RE: Lot 5 Block 6 Unit 19 Volcano Cliffs SAD 228 7816 Urraca St NW Building Permit Pad Certification

Engineers Stamp Date 1/3/17 (D10D003F25)

RE: Volcano Cliffs Subdivision Lot 5 Block 6 Unit 19 7816 Urraca St NW Grading and Drainage Plan Engineers Stamp Date 11/23/16 (D10D003F25)

Subject: 7816 Urraca St. NW

GRADING & DRAINAGE PLAN 7816Urraca Street, NW LOT 5, BLOCK 6, UNIT 19 VCS Sheet 2 of 2

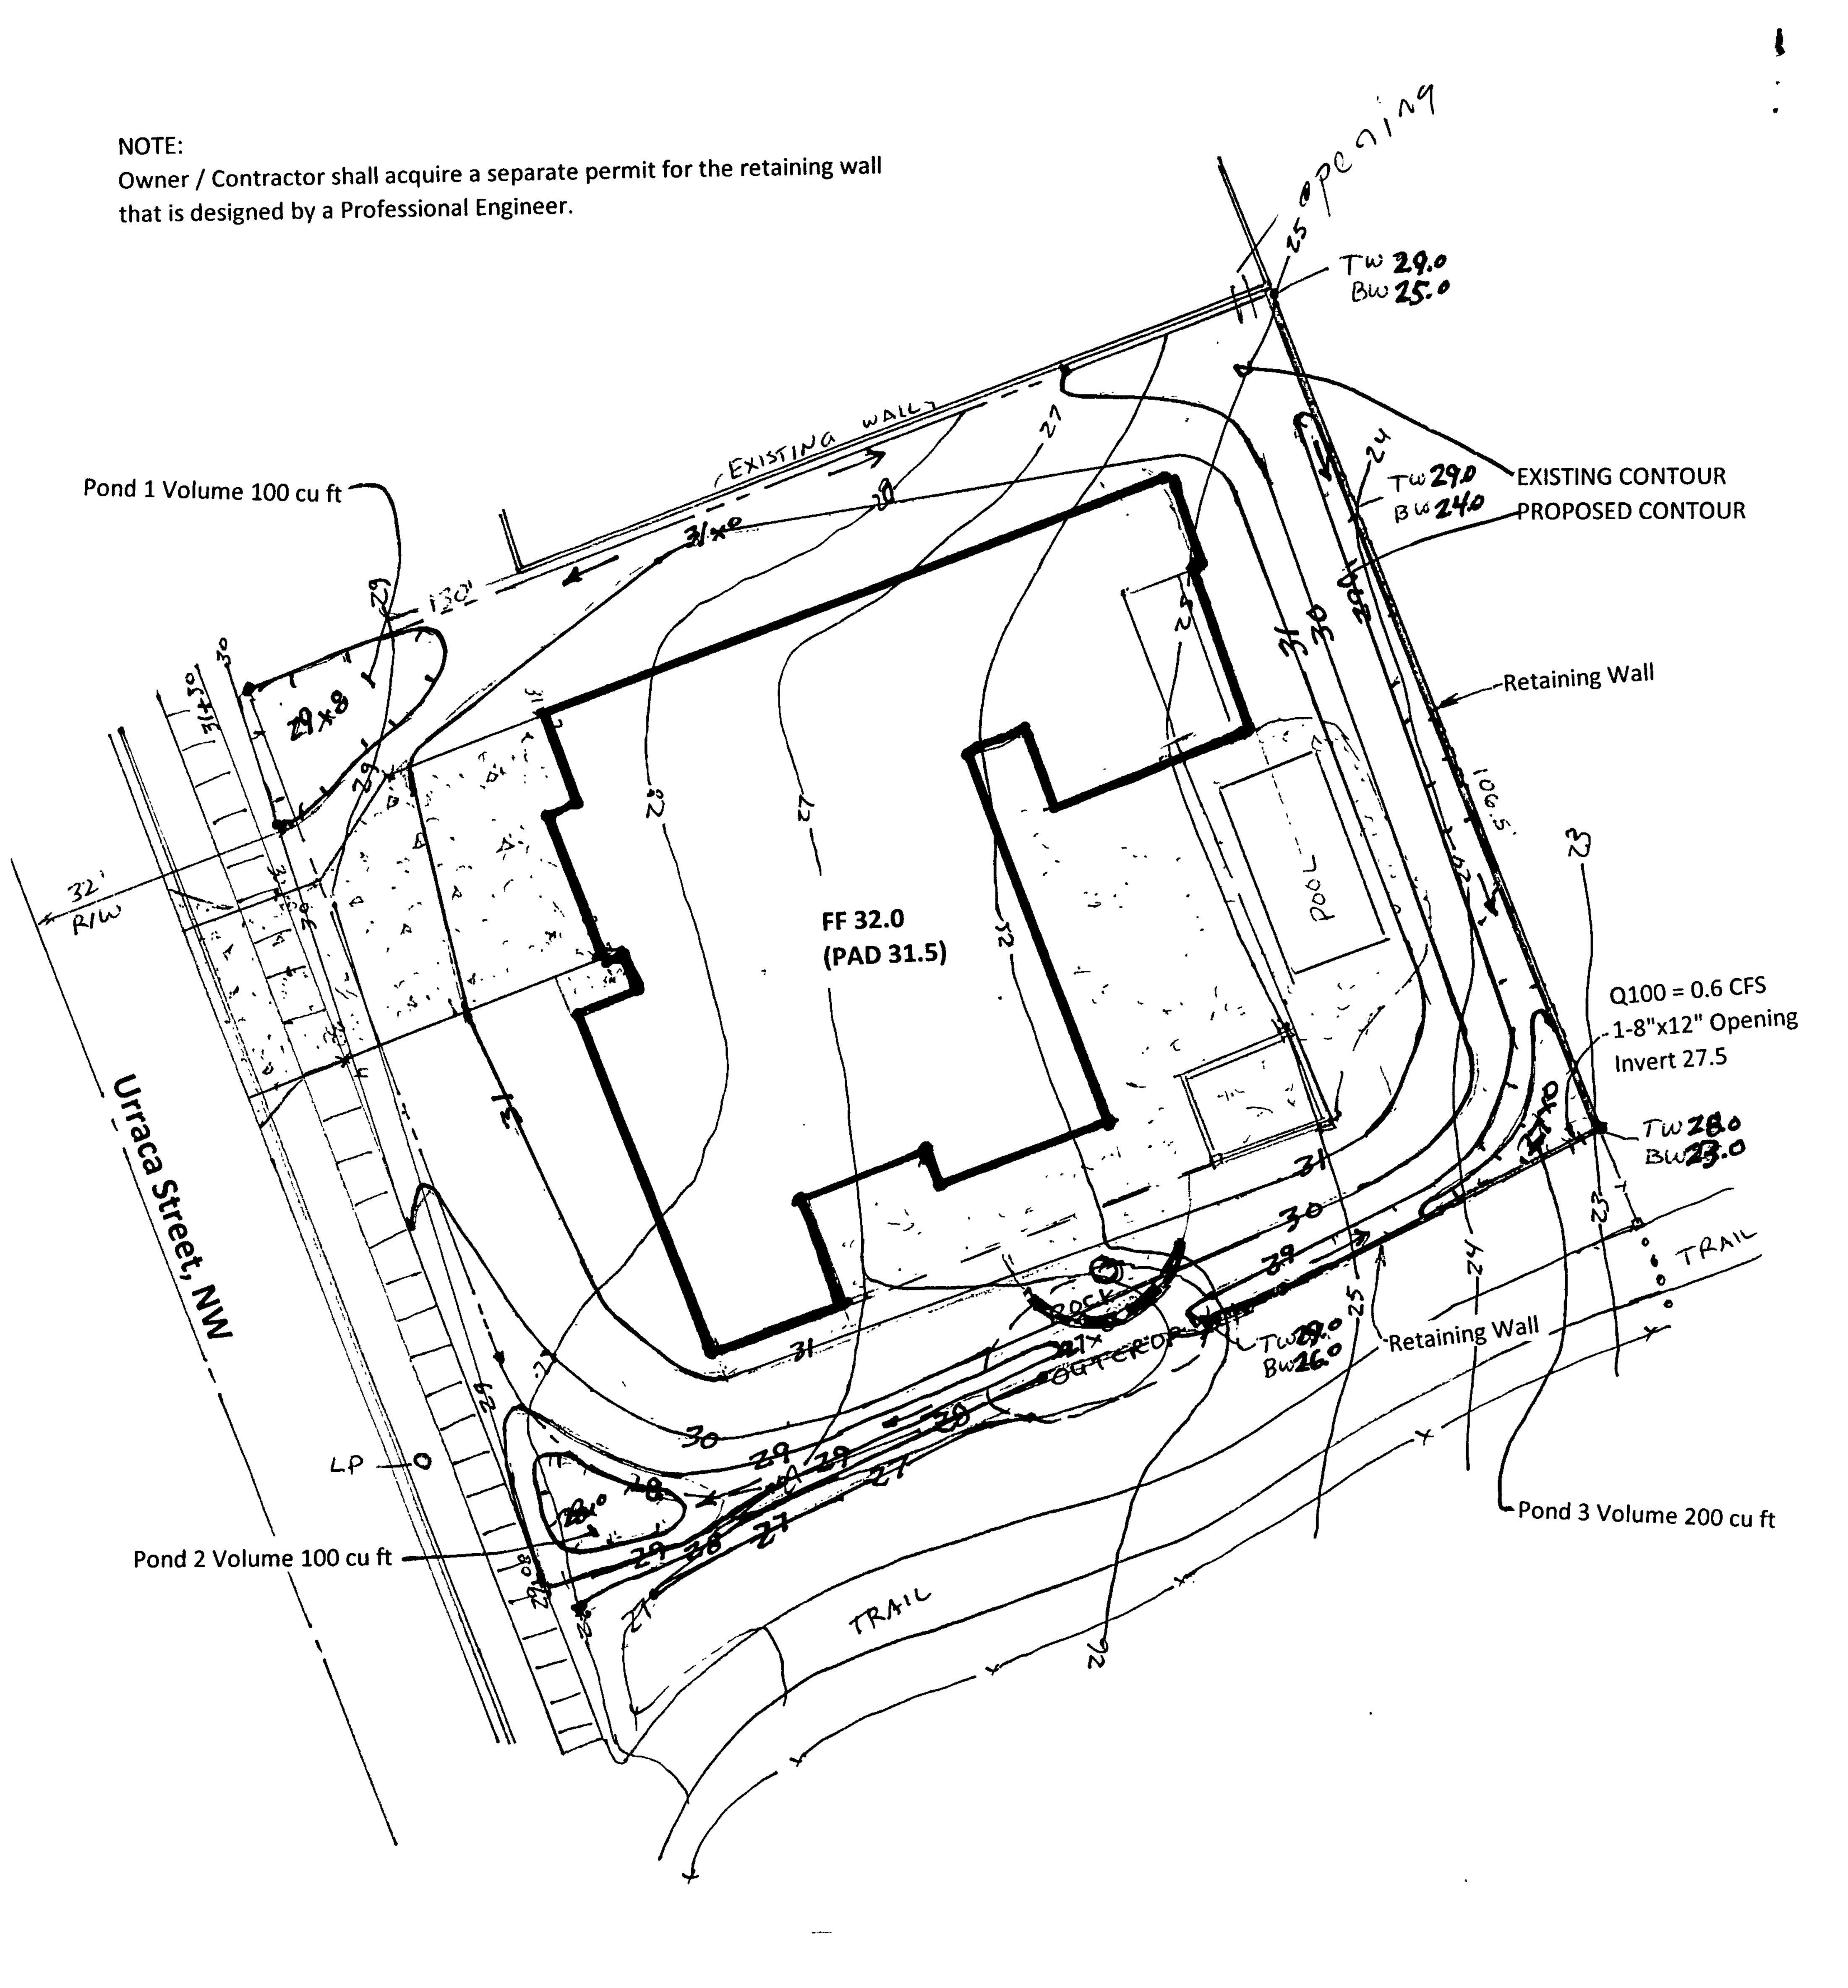
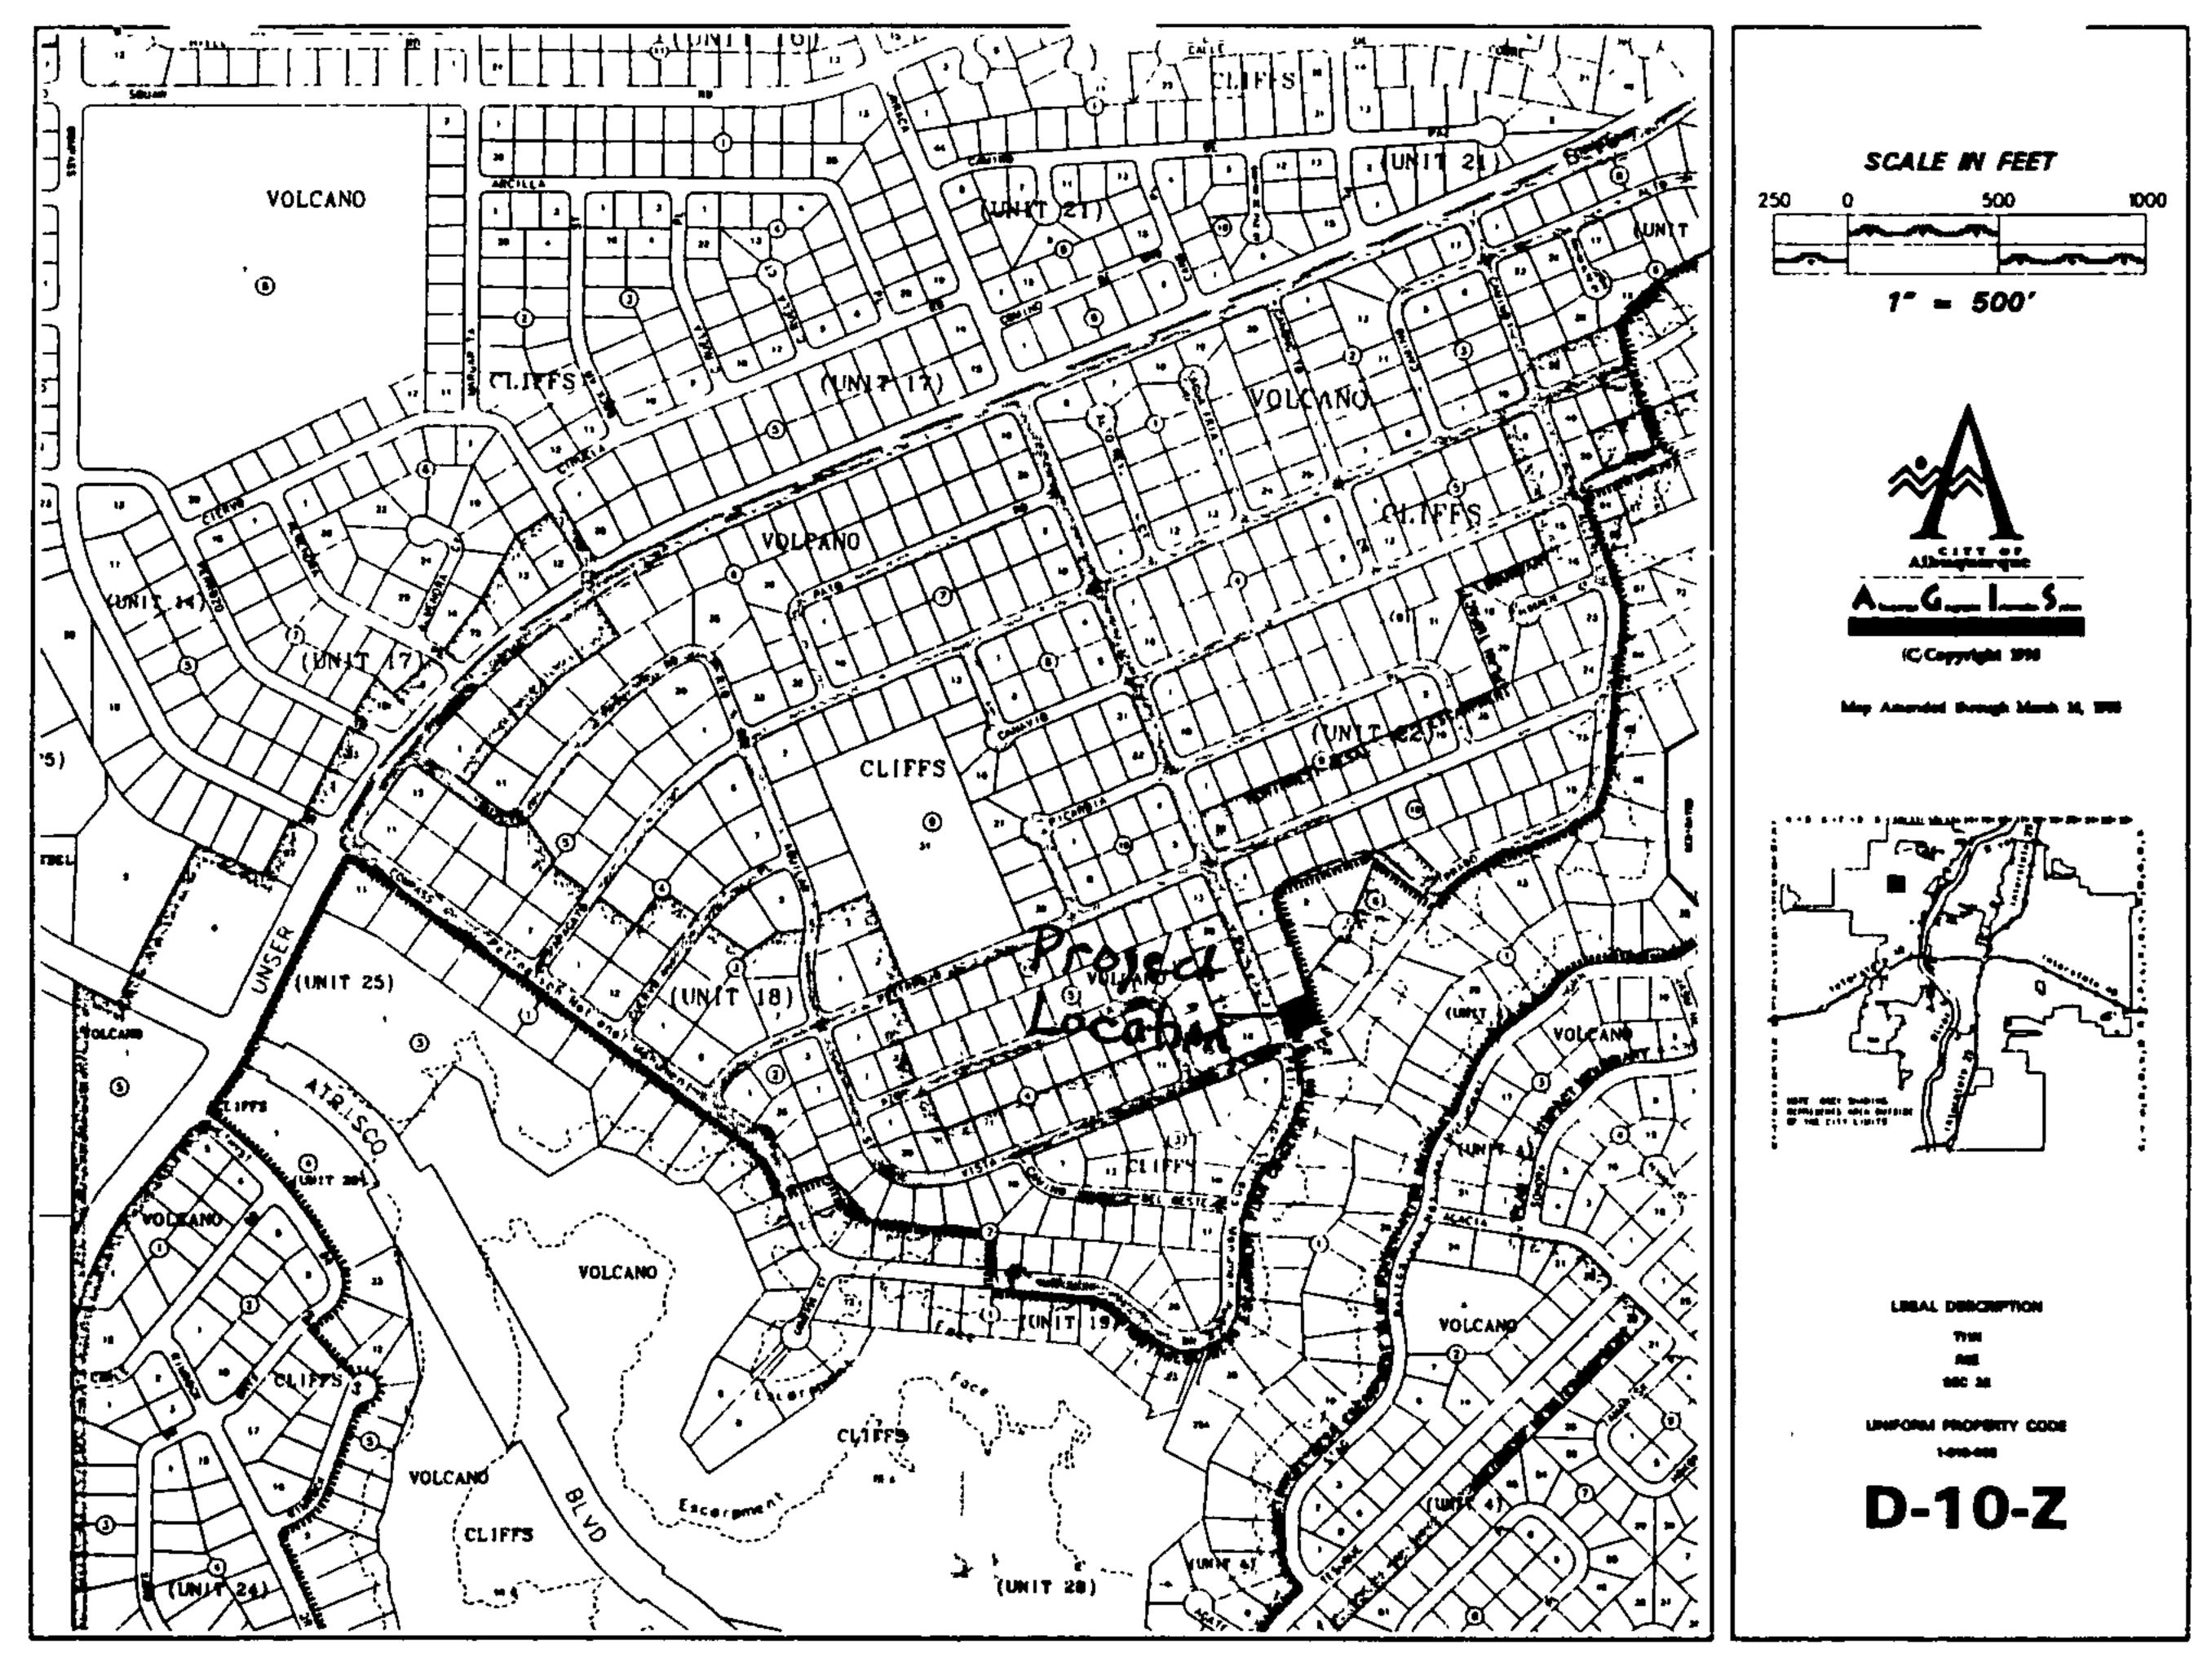
Based upon the information provided in your submittal received 11/22/16, the above referenced Grading and Drainage plan dated 11/22/16

cannot be approved for Grading Permit or Building Permit until the following comments are addressed:

- Provide an opening in the NE corner of the wall if a block wall is to be built.
- Provide a note stating that all walls/fences require a separate permit.
- Provide a note stating that a pad certification is required before slab is poured.
